To: Development Permit Panel
From: Joe Erceg
Manager, Development Applications
Date: March 19, 2003
File: DP 02-220758
Re: **Application by Onni Development Capital Corporation for a Development Permit at 12300 English Avenue**

Onni Development Capital Corporation has applied to the City of Richmond for permission to develop eight (8) townhouse units at 12300 English Avenue as referred to as 'Lot 47' on a site zoned Comprehensive Development District (CD/101).

PROJECT: IMPERIAL LANDING
 FOR: STEVESTON, B.C.
 CLIENT: CAPITAL CORPORATION
 DRAWING TITLE: CONTRACT PLAN
 CONTRACT NO.: LOT #47
 PROJECT NUMBER: 0220758
 DRAWN: DEBBIE
 SCALE: 1/4"=1'-0"
 SHEET NUMBER: A100

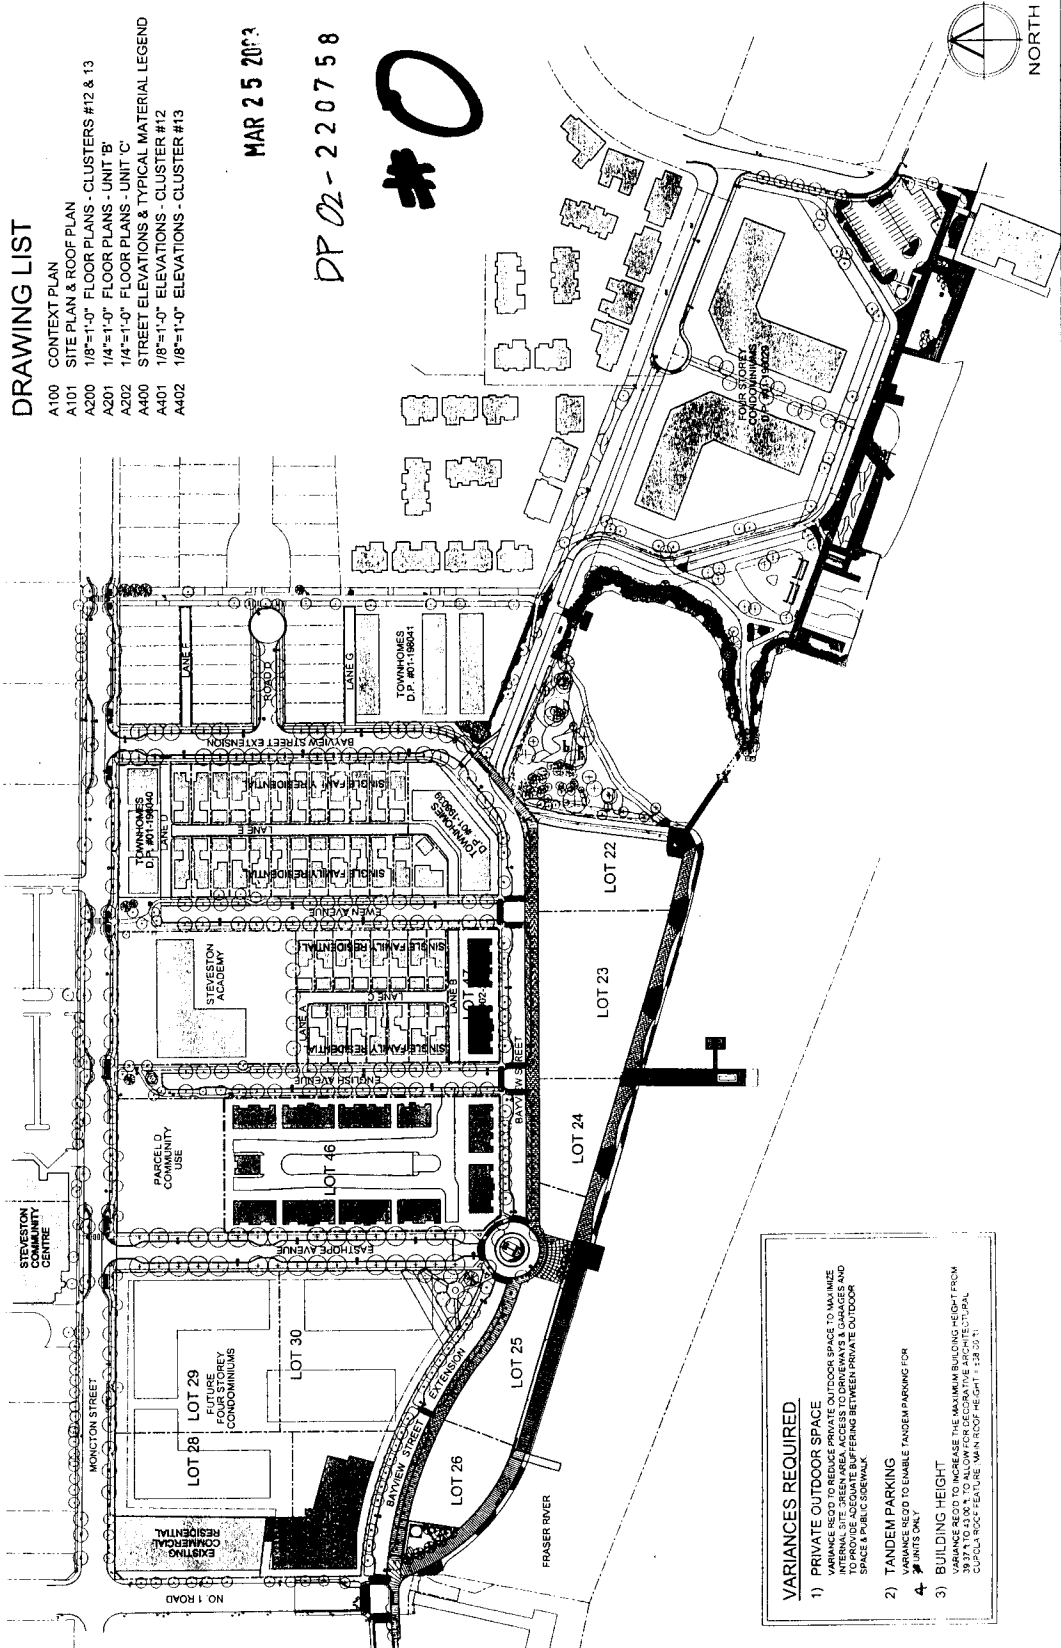
1. Update the Context Plan on drawing ‘A100 - Title Page & Site Statistics’ dated December 24, 2002.
 - a) Reference the following recently approved Development Permits on the Context Plan:
 - DP 01-198029 at 4500 and 4600 Westwater Drive;
 - DP 01-198039 at 4311 Bayview Street;
 - DP 01-198040 at 4388 Moncton Street; and
 - DP 01-198041 at 4388 Bayview Street.
 - b) Update the ‘Steveston Academy’ site planning information.
 - c) Include the preliminary design intent (i.e. anticipated building footprints and massing) for Lots 27, 28, 29 and 30 to the south.
 - d) Ensure that the Context Plan clearly differentiates between, recently approved, currently proposed and future development sites within the overall Imperial Landing development. ***The applicant has provided the above information with the final submission. See the revised context plan.***

**CLUSTER #13
 FRONT ELEVATION**
 SCALE: 1/8" = 1'-0"

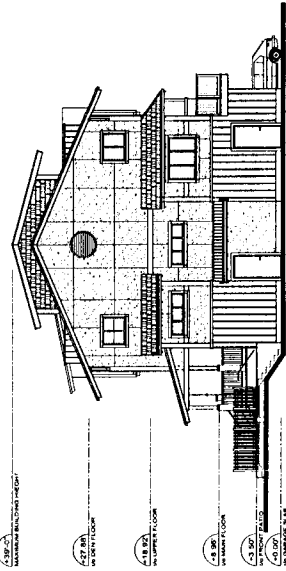
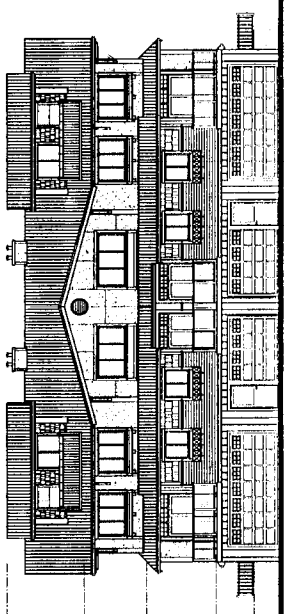
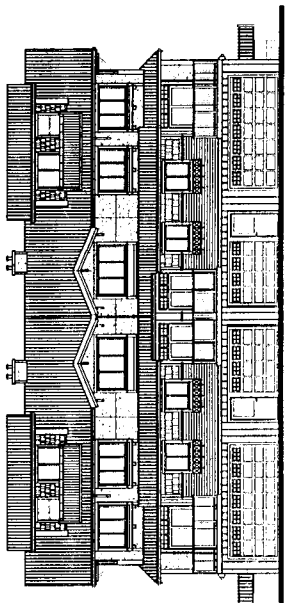
3. The mansard roof form of building cluster 13 appears foreign. Consider referencing the typical roof design of the former cannery structures with large shed roofs. The proposed flat roof is not supported. The applicant is requested to consider a simplified, large shed or pitched roof form with a variety of dormers (i.e. maintain the roof height but reduce the roof pitch) rather than a mansard roof. The large gable ends of a pitched roof will also create an opportunity to add further interest to the building façades. The metal roof material is supported however; staff prefers a standing-seam versus ribbed or folded metal roof. ***The roof form of building cluster 13 has been revised and the mansard roof has been eliminated. All flat roofs have been replaced with large shed roof forms. A high profile ribbed metal roof material is to be used. Please refer to the revised drawings.***
